London School Of Hygiene & Tropical Medicine TP2

Drawing issue for Section 96a Planning Submission

25/04/2019

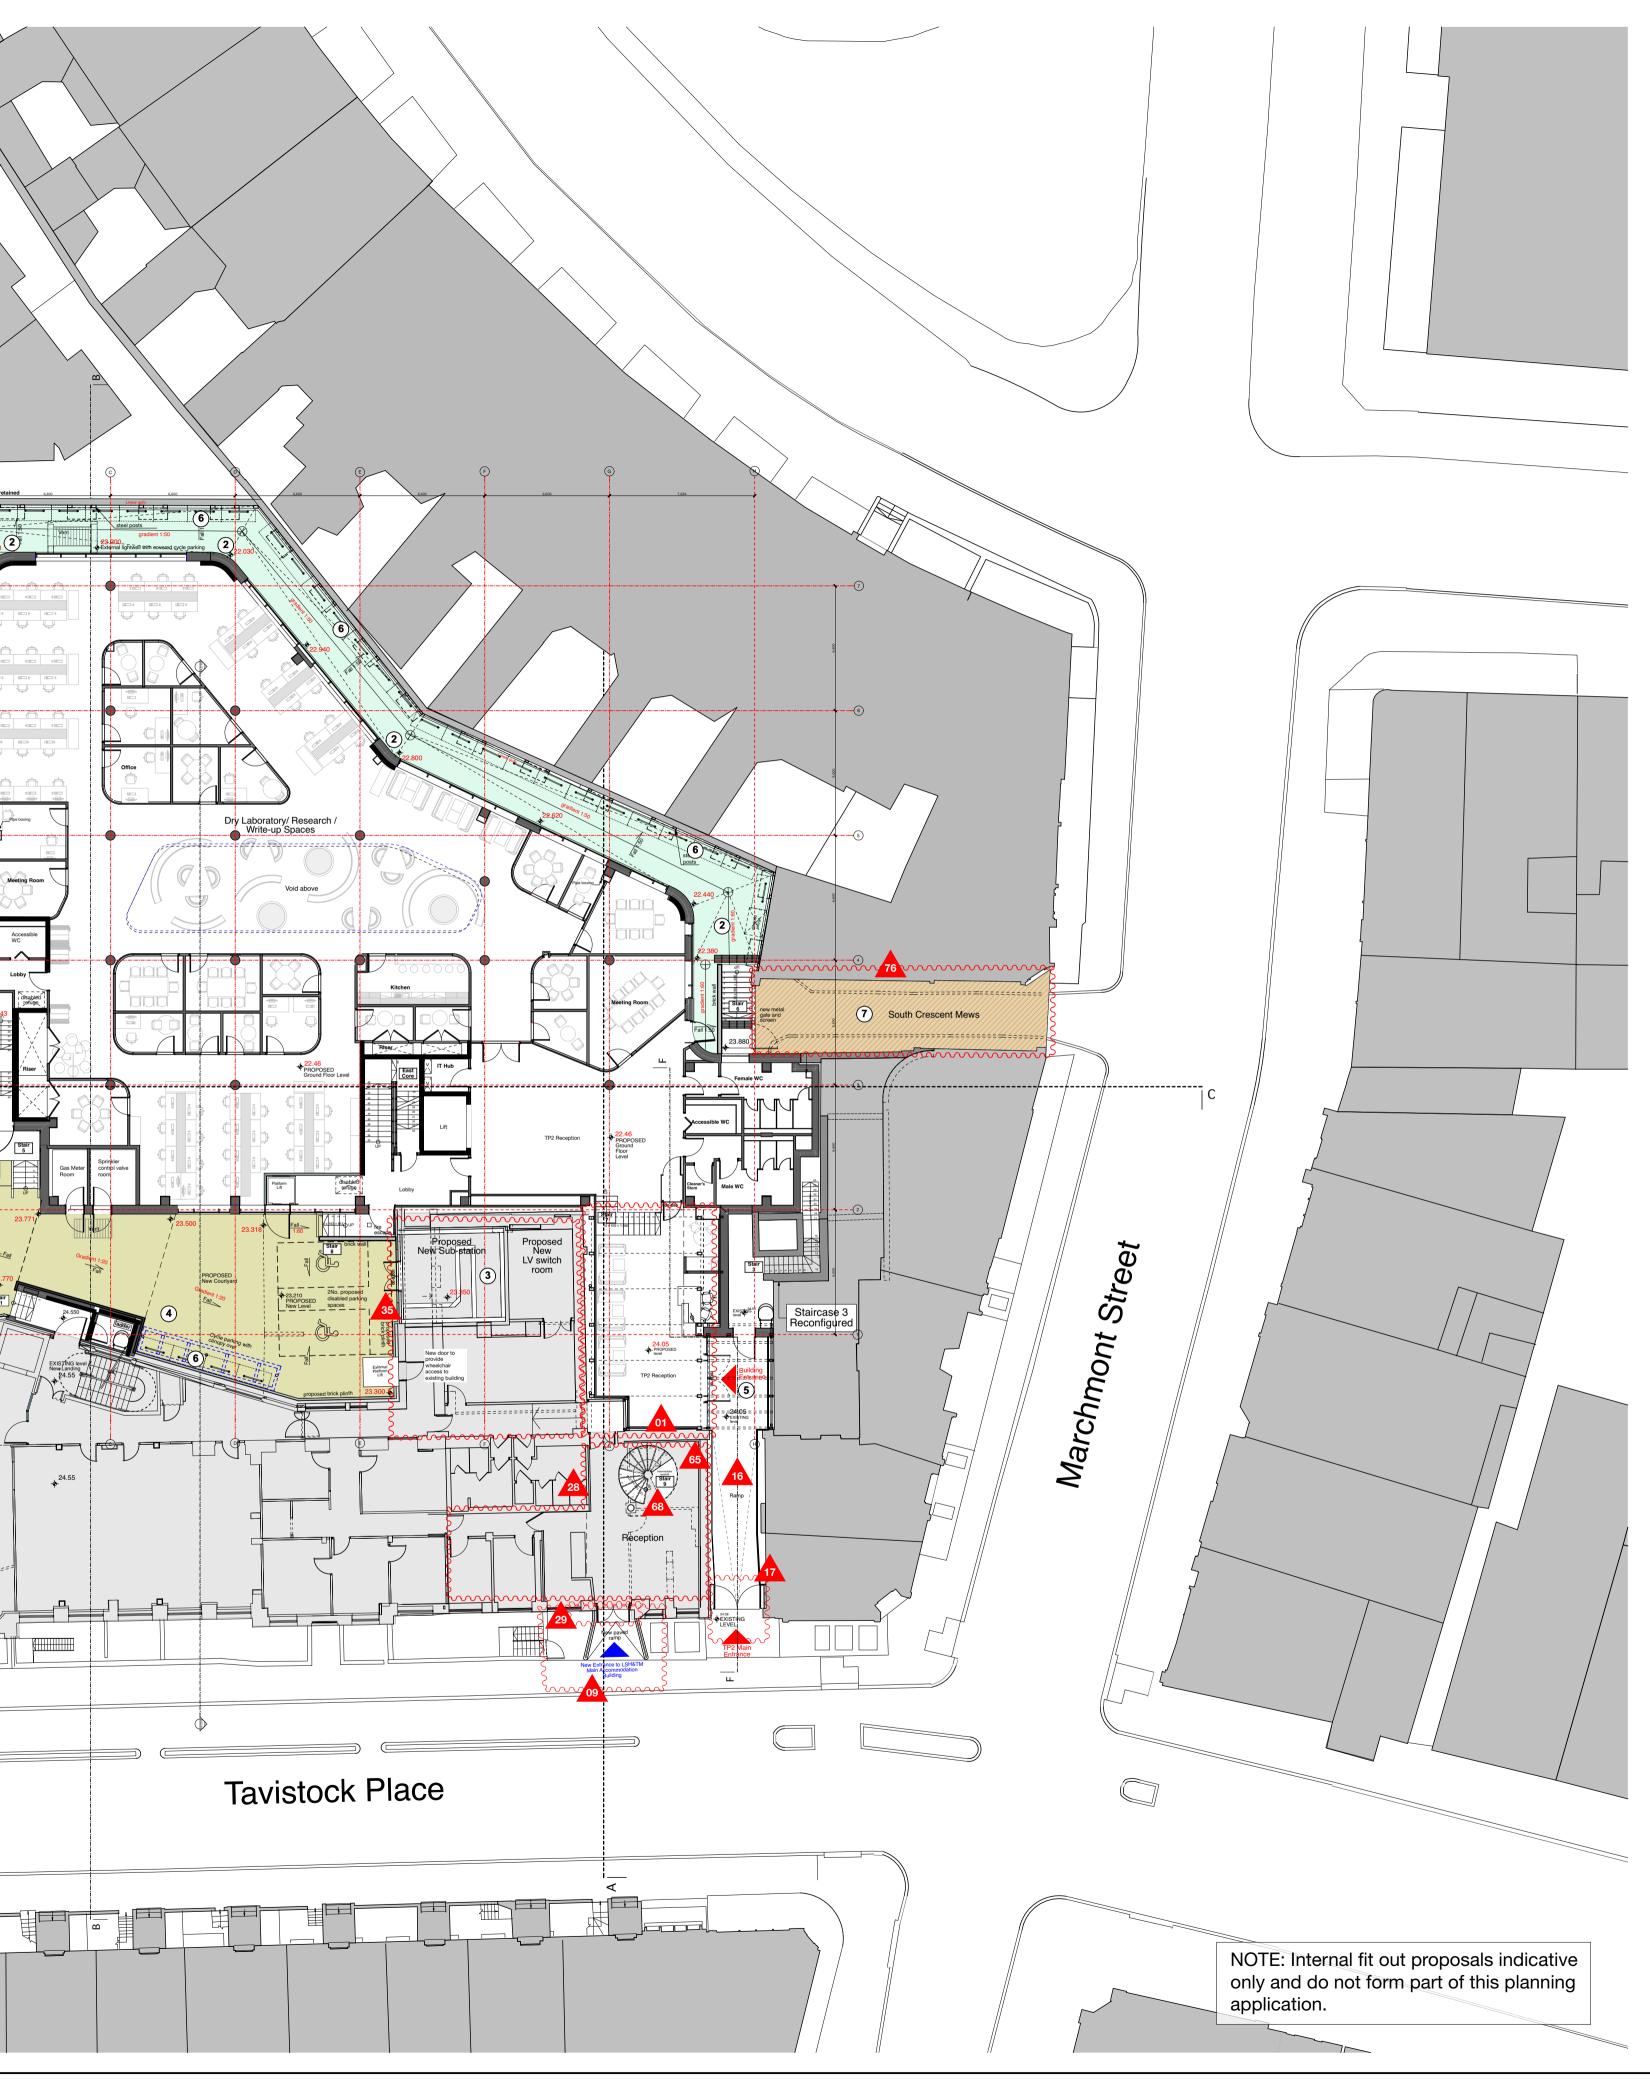
EGEND (ALL CHANGES TO ALL LEVELS)         Stair 2 cmitted, and glazed entrance enclosure enlarged         Window added         New steps to base of external spiral stair         Stair 3 nord and gable end arrangement revised.         Level 3 accommodation manaarded         Roof light size, height and position adjusted, and smoke vents added.         Louvres omitted.         Poor light size, height and position adjusted to suit amended stair landing levels.         External ramp adjusted, and ralings added.         Low brick plinth added to base of external walls to TP2.         Brick plinth added to base of external walls to TP2.         Brick plinth added to base of external walls to TP2.         Brick plinth added to base of external walls to TP2.         Brick plinth added to base of external walls to TP2.         Brick plinth added to base of external walls to TP2.         Brick plinth added to base of existing buildings within courtyard.         Gallery passageway to TP2: finishes revised.         Gallery passageway to TP2: finishes revised.         Gallery passageway to TP2: relates adjusted         Prives durm-table size and position         Entrance ramp gradient and levels adjusted         Prives dor ramp omitted         Fail restraint added         Gate removed         Maintenance acceses door added

1       Stair 3 roof and gable end arrangement revised.         2       Level 3 accommodation mansarded         2       Roof light size, height and position adjusted, and smoke vents added.         2       Louves omitted.         3       Roof light size, height and position adjusted, and smoke vents added.         4       External ramp adjusted, and railings added.         5       External paving levels in courtyard raised to achieve required paving falls.         6       Low brick plinth added to base of external walls to TP2.         6       Brick plinth added to base of external walls to TP2.         6       Brick plinth added to base of external walls to TP2.         6       Brick plinth added to base of external walls to TP2.         6       Brick plinth added to base of external walls to TP2.         6       Gallery passageway to TP2: finishes revised.         6       Gallery passageway: entrance gates design revised.         7       Privest door ramp omitted         8       Finarenance access door added         9       Parapet revised         10       Maintenance access door added         11       Parapet revised         12       Parapet revised         13       Modifications to windows, doors and facades facing into courtyard.         14 <td< td=""><td>alterations.</td></td<>	alterations.

•       External ramp adjusted, and railings added.         •       West stair core glazing fenestration adjusted to suit amended stair landing levels.         •       External paving levels in courtyard raised to achieve required paving falls.         •       Low brick plinth added to base of existing buildings within courtyard.         •       New steps and landing added outside room G1, and internal steps omitted.         •       Bin store enlarged and repositioned.         •       Gallery passageway: entrance gates design revised.         •       Window on north elevation of TP2 reduced in length.         •       Revised tum-table size and position         •       Entrance ramp gradient and levels adjusted.         •       External levels adjusted         •       Parapet revised         •       Roof/wall shape adjusted         •       Parapet revised         •       Revised door design         •       Modifications to windows, doors and facades facing into courtyard.         •       Gate retained and modified         •       Bike canopy detail revised (typical condition highlighted)         •       Sub-statin & LV switch-room revised including external doors, and adjoining internal alterations         •       Revised proposal for bike storage replacing existing bike racks in Dairy shed.	alterations.

External paving levels in courtyard raised to achieve required paving falls.         Low brick plinth added to base of external walls to TP2.         Brick plinth added to base of existing buildings within courtyard.         New steps and landing added outside room G1, and internal steps omitted.         Binstore enlarged and repositioned.         Gallery passageway: entrance gates design revised.         Gallery passageway: entrance gates design revised.         Revised turn-table size and position         Entrance ramp gradient and levels adjusted.         External levels adjusted         TP1 west door ramp omitted         Galery passageway: entrance gates design internal alterations         Revised turn-table size and position         Gates removed         Maintenance access door added         Parapet revised         Root/wall shape adjusted         TP1 reception relocated, and associated internal alterations         Revised door design         Modifications to windows, doors and facades facing into courtyard.         Gate etails revised         Revised proposal for bike storage replacing existing bike racks in Dairy shed.         Steps adjusted         Sub-station & LV switch-room revised including external doors, and adjoining internal alterations         Steps adjusted         Cladding changed to brass finish	alterations.

Gates removed         Maintenance access door added         Parapet revised         Roof/wall shape adjusted         TP1 reception relocated, and associated internal alterations         Revised door design         Modifications to windows, doors and facades facing into courtyard.         Gate details revised         Revised proposal for bike storage replacing existing bike racks in Dairy shed.         Gate retained and modified         Bike canopy detail revised (typical condition highlighted)         Sub-station & LV switch-room revised including external doors, and adjoining internal alt         Steps adjusted         Cladding changed to brass finish         Wall mounted planters revised (typical condition highlighted)         Steel posts added to boundary wall (typical condition highlighted)         Height of glazed entrance roof increased to suit required pitch.         Glazed entrance roof and canopy revised         New roof guarding to existing flat roof         Screening fins and cladding added         Louvres added         Ramp omitted         Door removed and infilled	alterations.

<ul> <li>Sub-station &amp; LV switch-room revised including external doors, and adjoining internal alt</li> <li>Steps adjusted</li> <li>Cladding changed to brass finish</li> <li>Wall mounted planters revised (typical condition highlighted)</li> <li>Steel posts added to boundary wall (typical condition highlighted)</li> <li>Height of glazed entrance roof increased to suit required pitch.</li> <li>Glazed entrance roof and canopy revised</li> <li>New roof guarding to existing flat roof</li> <li>Screening fins and cladding added</li> <li>Louvres added</li> <li>Bamp omitted</li> <li>Door removed and infilled</li> </ul>	
<ul> <li>Steps adjusted</li> <li>Cladding changed to brass finish</li> <li>Wall mounted planters revised (typical condition highlighted)</li> <li>Steel posts added to boundary wall (typical condition highlighted)</li> <li>Height of glazed entrance roof increased to suit required pitch.</li> <li>Glazed entrance roof and canopy revised</li> <li>New roof guarding to existing flat roof</li> <li>Screening fins and cladding added</li> <li>Louvres added</li> <li>Ramp omitted</li> <li>Door removed and infilled</li> </ul>

<ul> <li>2 New roof guarding to existing flat roof</li> <li>3 Screening fins and cladding added</li> <li>4 Louvres added</li> <li>5 Ramp omitted</li> <li>6 Door removed and infilled</li> </ul>	C Spiral Spiral 23.7
<ul> <li>3 Screening fins and cladding added</li> <li>4 Louvres added</li> <li>5 Ramp omitted</li> <li>6 Door removed and infilled</li> </ul>	C Spiral Spiral 23.7
<ul> <li>4 Louvres added</li> <li>5 Ramp omitted</li> <li>6 Door removed and infilled</li> </ul>	C Spiral Spiral 23.7
<ul> <li>5 Ramp omitted</li> <li>6 Door removed and infilled</li> </ul>	Spiral Spiral
6 Door removed and infilled	
	Reinstated
Access hatch adjusted.	
8 Depth of green/blue roof build-up adjusted.	
9 Blue roof incorporated into green roof and gravel margins added.	
0 Cladding build-up adjusted	
Orientation of brass seams adjusted	
2 Roof gutters revised.	
3 Means of escape revisited and exit door added to TP1	
4 Spiral staircase landings added at each floor

5 Door modified	
6 Basement louvers to external metal staircase landings	24.060 Service Entrance
7 Revised proposal for mean of escape in TP1	
8 Revised proposal for window and door	
9 Revised proposal for door to be left as current	
Gate to be removed	Existing opening Ramo
Capping width adjusted and roof planters shown indicatively.	Swith new glass
2 Door to be replaced	
3 Revised proposal for the entrance	
Gates and Entrance door in TP1 to be replaced	
Existing stair to be demolished	
Existing window and door to be replaced	Service Entrance
8 New reconfiguration for new spiral stair, WCs and adjoining internal spaces.	
9 Staircase partially demolished	22~~~
0 Level adjusted	
Lift pit adjusted	
2 Level updated	
Red line extended to include South Crescent Mews	
4 Red line extended to include new ramp and frontage	· ·
5 Ladder added	
6 Works to Mews paving/kerbs added	
7 Minor adjustment to ridge, and eaves line, (not affecting
